RE: Bert Avenue Landfill
Cuyahoga County
Waste Stabilization Report
Notice of Deficiency

TO: Jerry Parker, DSIWM-NEDO
FROM: Doug Evans, DSIWM-CO
SUBJECT: Slope Stability Comments for Bert Avenue Site
DATE: May 18, 1998

Pursuant to your request, I have reviewed the slope stability analysis portion of the report titled, *Waste Stabilization Study Report*, dated March 27, 1998, and the report titled *Eastern Slope Stability Evaluation-Addendum*, dated April 13, 1998. Both reports were prepared by Dames & Moore and address stability issues with the proposed design of the waste containment cell at the Bert Avenue Site.

Earthquake-Induced Deformations (6.5 M)

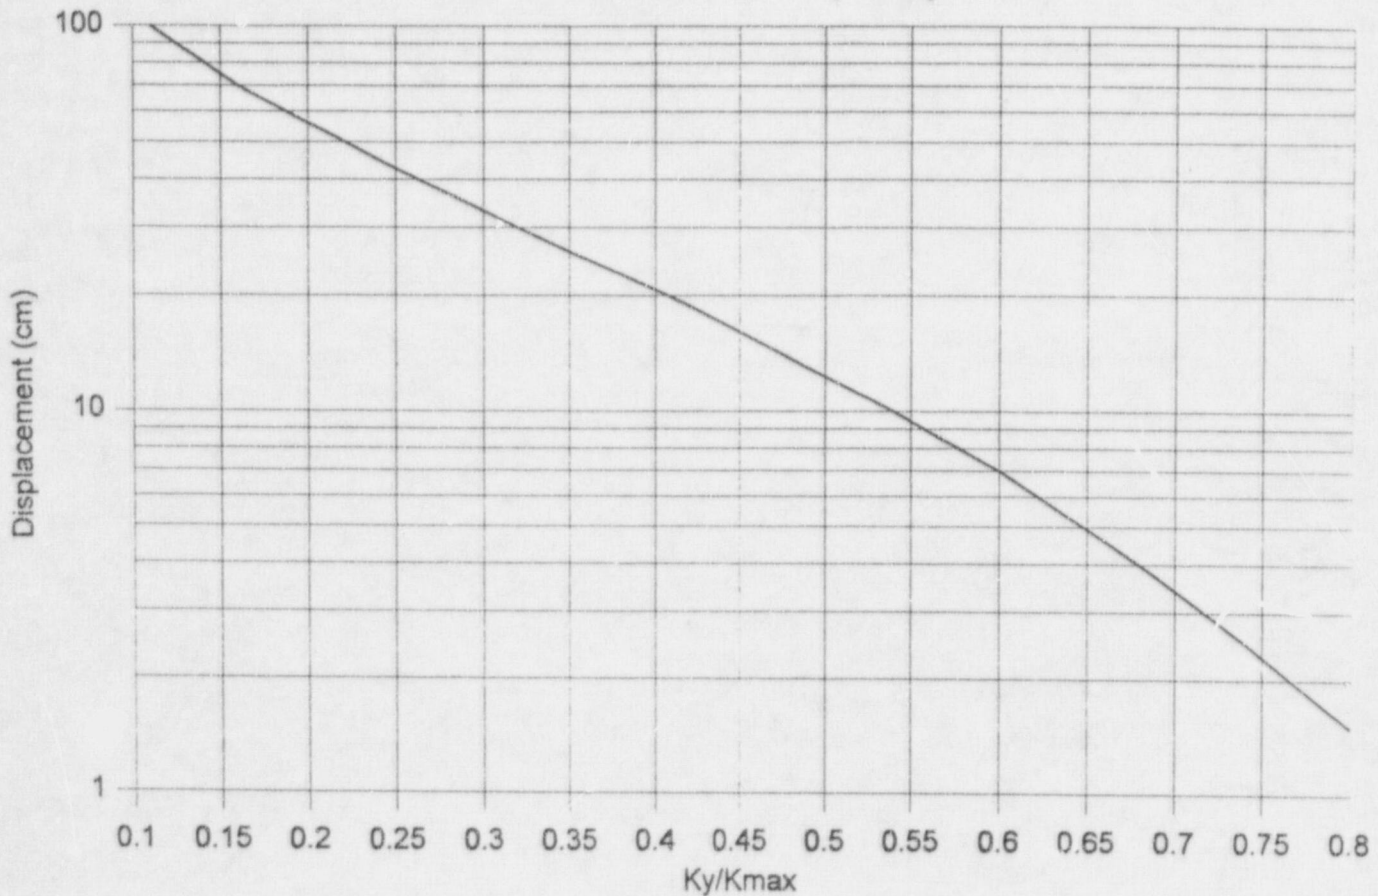
The FOS (0.95) for deep-seated translational failures involving the GCL is less than the regulatory minimum recommended value of 1.1. However, a simplified Newmark deformation analysis indicates that minimal deformation will occur due to the design earthquake.

- The yield acceleration for this failure scenario is calculated to be 0.125g.
- The maximum seismic acceleration has been estimated to be 0.16g.
